W-REF: P24-447 Drury Centre Stage

18 September 2025

Road 25 Culvert Design Memorandum

Drury Centre Stage 2 - Fast Track

Figure 1: Location of proposed culvert under Road 25

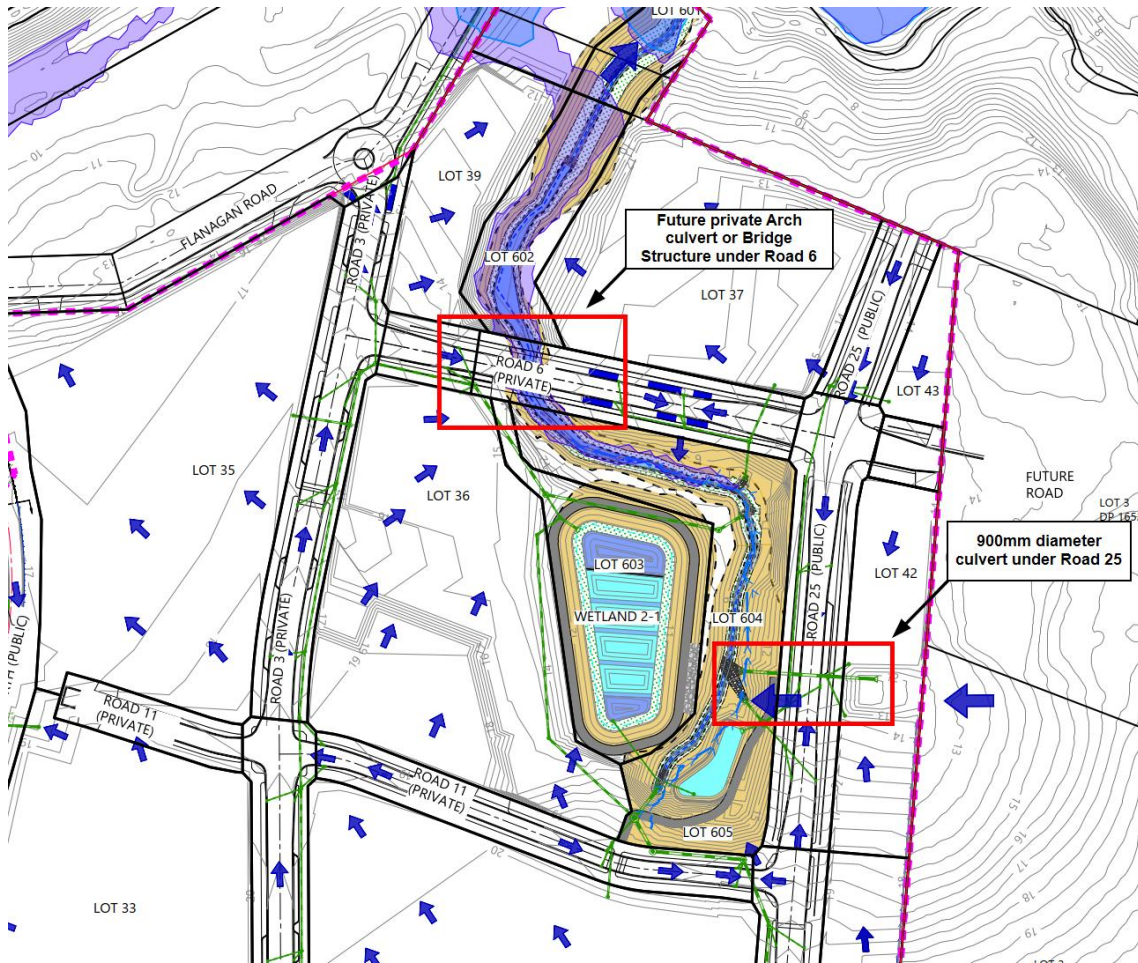
“Item 7(a) Drawing no. P24-447-01-3200DR shows the Stage 2 catchment boundary along the eastern side of Lot 42, however there is a blue arrow indicating runoff from a contributing catchment outside the Stage 2 area, flowing in a westerly direction towards Wetland 2-1. Please advise if the proposed stormwater pipes and any other parts of the proposed stormwater infrastructure in Stage 2 have been designed for flow originating from outside Stage 2 and how this is addressed with respect to future land use assumptions in assessing runoff and relevant consent conditions.”

Flows coming from the contributing catchment outside of Stage 2 flowing in a western direction discharge via a culvert under Road 25 to Stream A, as shown in Drawing No. P24-447-01-3200-DR.

Figure 1 shows the location of the Culvert under Road 25.
